JORDAN VALLEY WATER TREATMENT PLANT
FILTER AND CHEMICAL FEED UPGRADES

JVWCD PROJECT #4289

ADDENDUM NO. 2
TO THE
CONTRACT DOCUMENTS

APRIL 2025

EM015 PEA GRAVEL EMBEDDED DUCT BANK
TYP
01/23/25

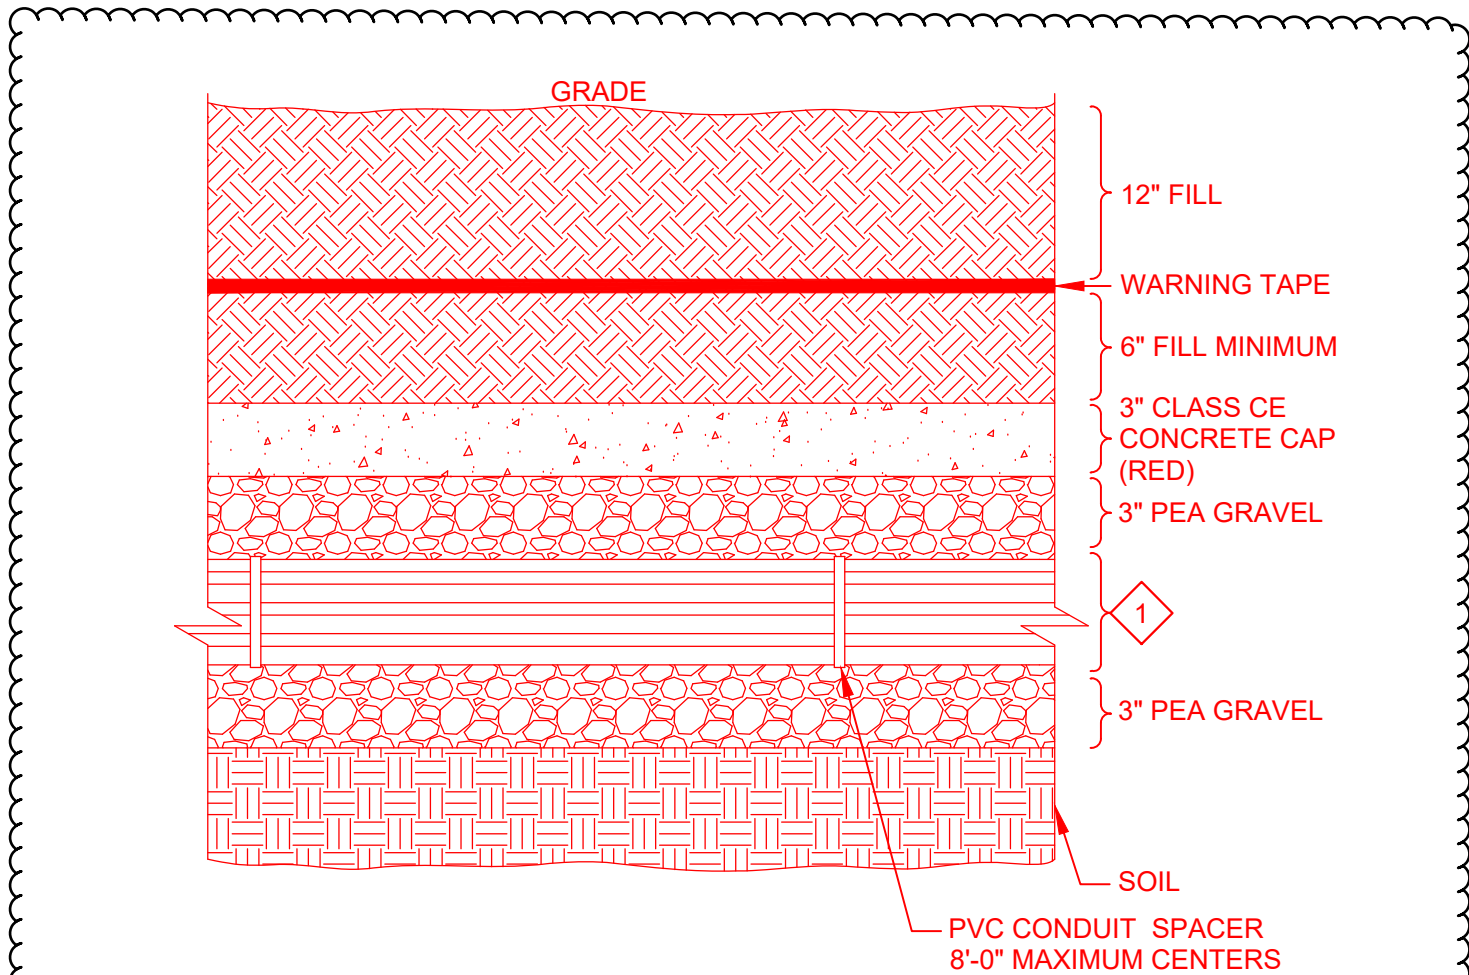
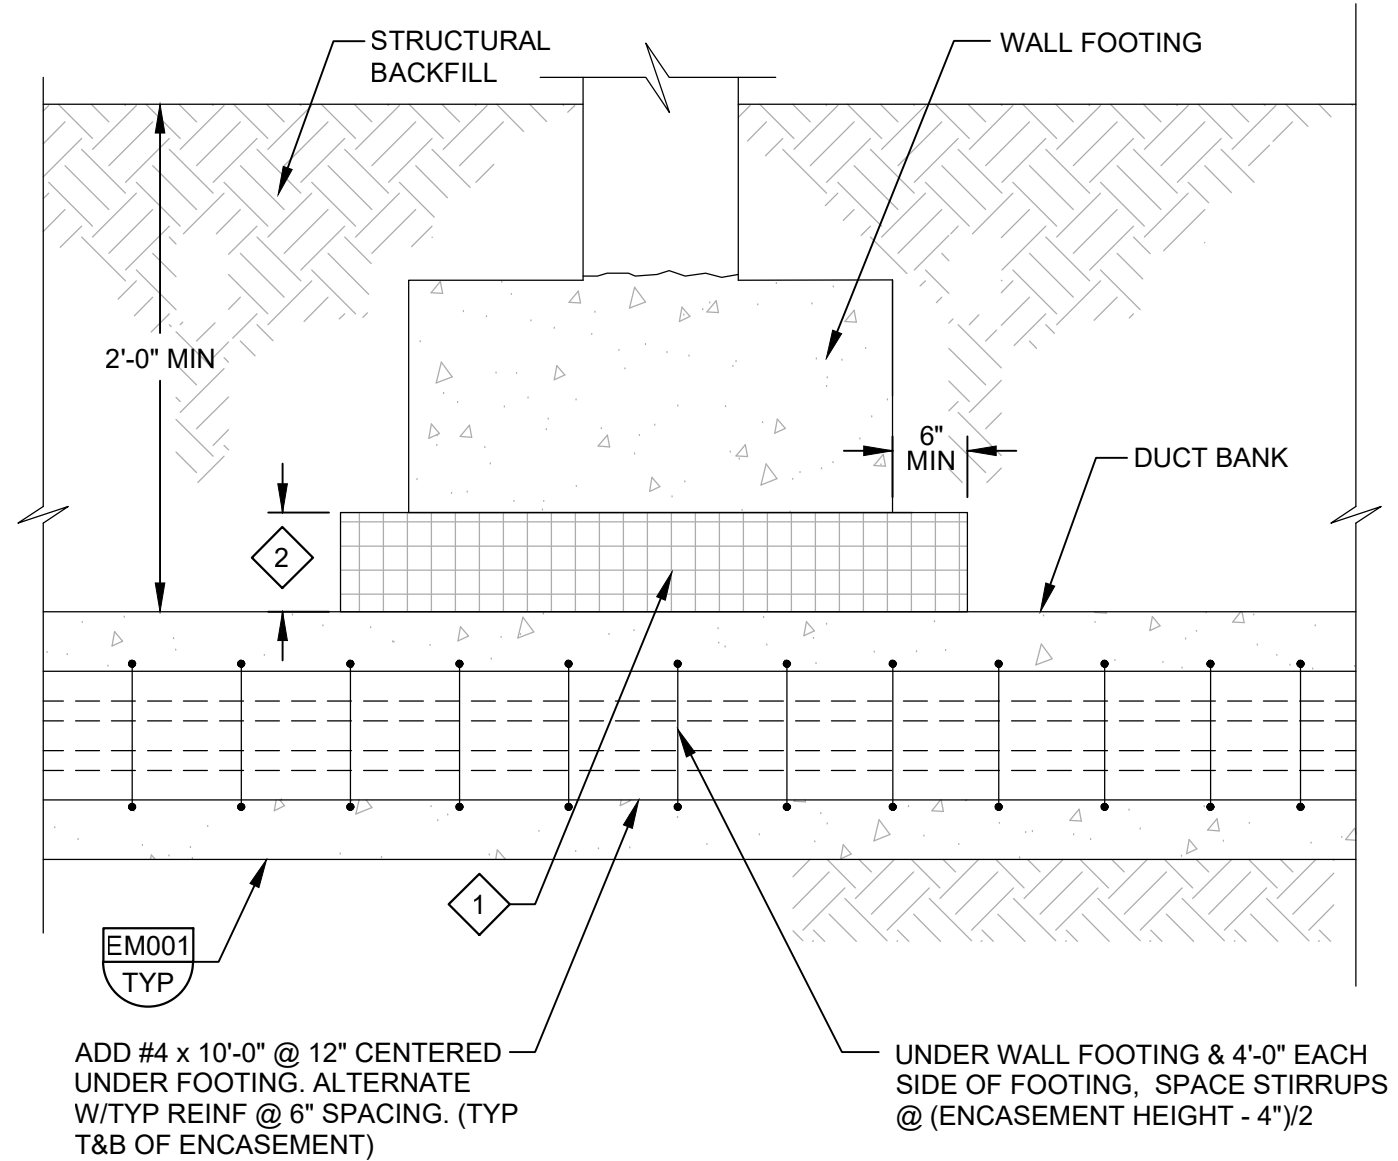
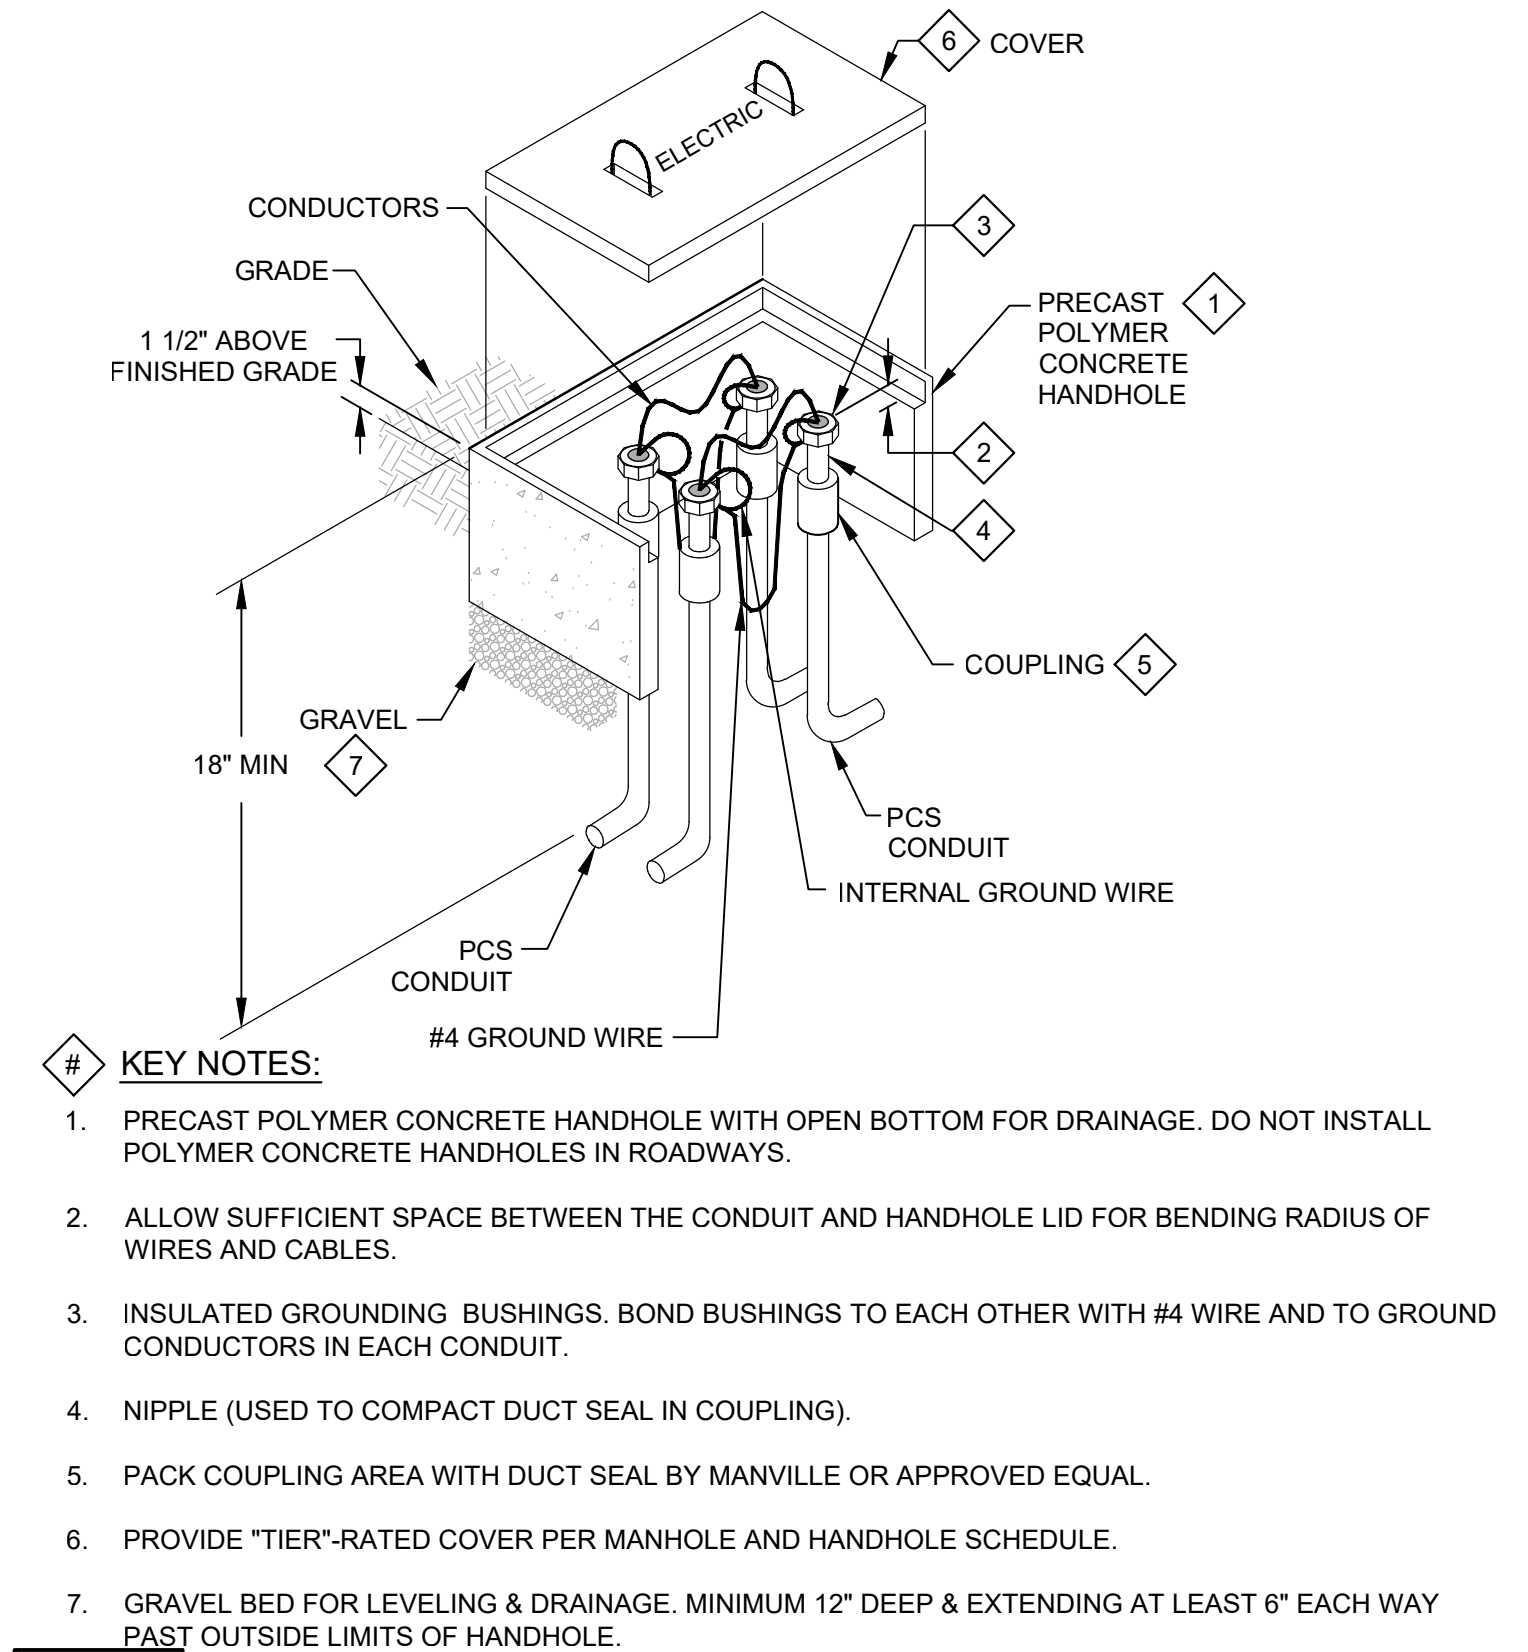
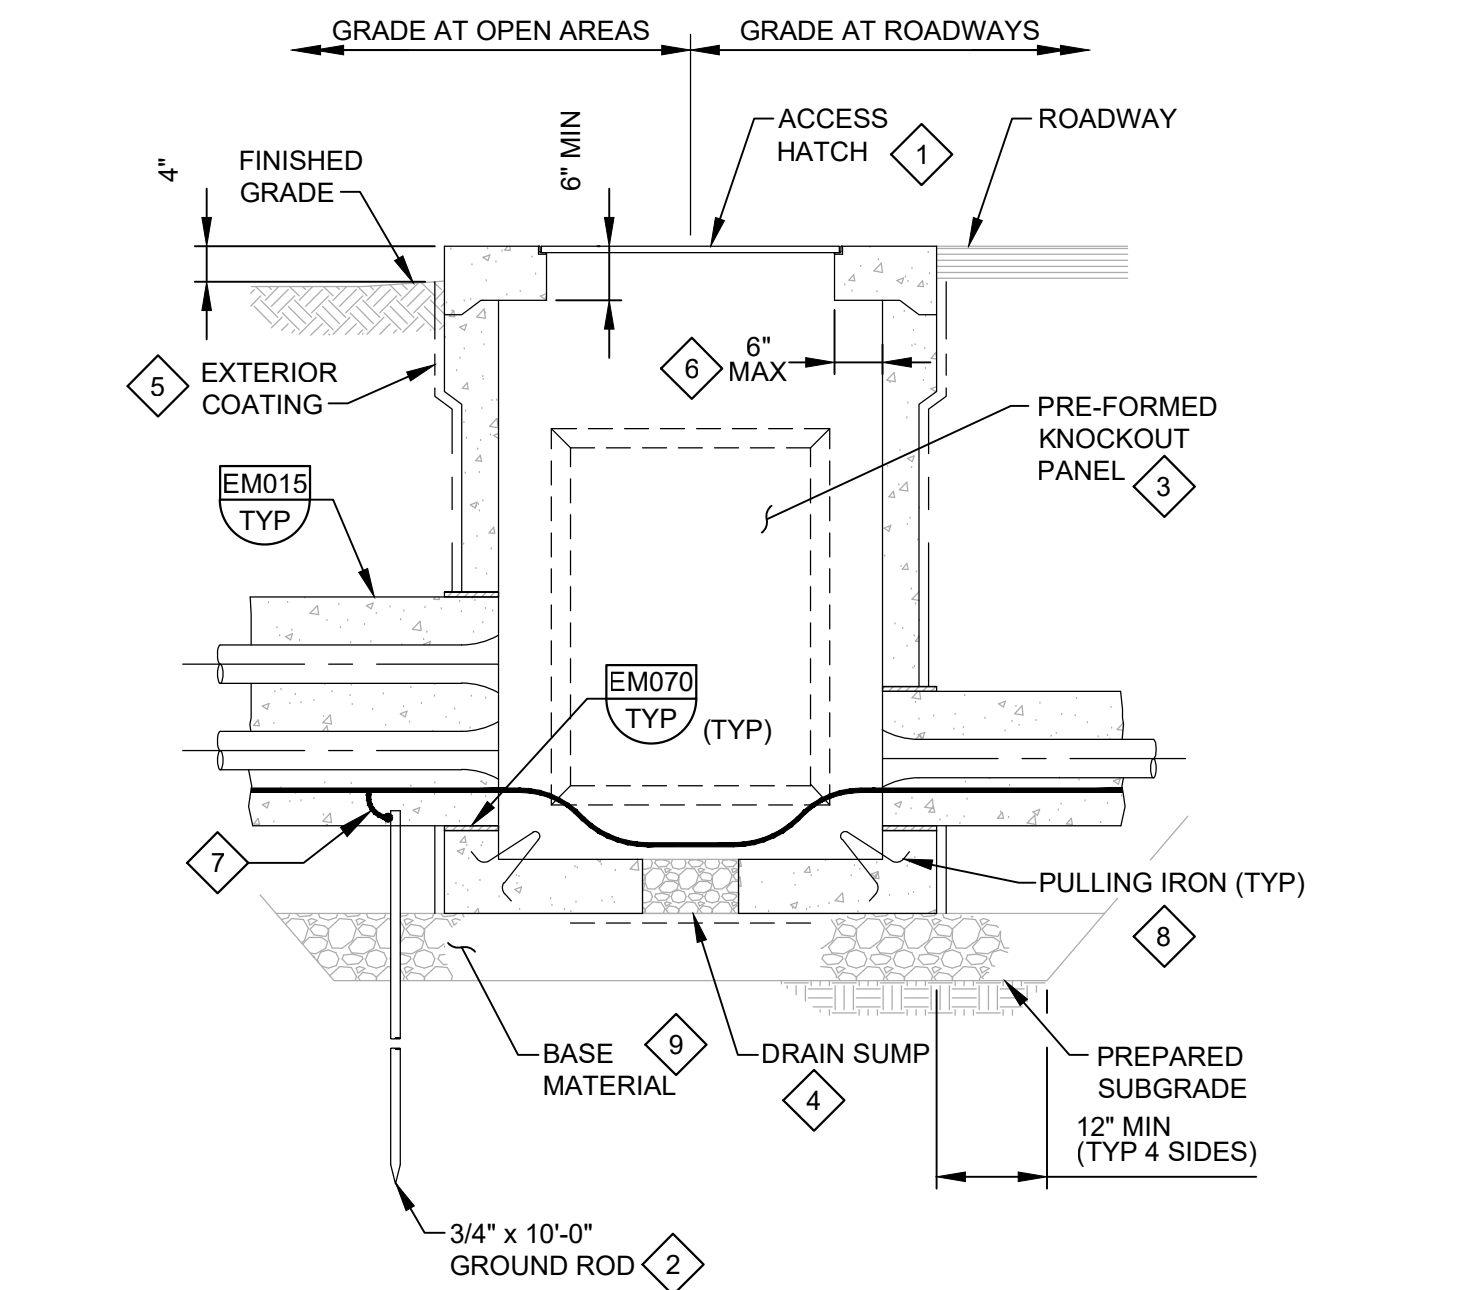
EM021 DUCT BANK CROSSING UNDER FOOTER
TYP
01/23/25

EM052 ELECTRICAL HANDHOLE: PRECAST POLYMER CONCRETE
TYP
01/23/25

EM071 ENCASED CONDUITS AT MANHOLES OR STRUCTURES - WITH WATERSTOP
TYP
01/23/25

EM072 DUCT BANK CONNECTION TO EXISTING HANDHOLE, PULL BOX, OR WALL
TYP
01/23/25
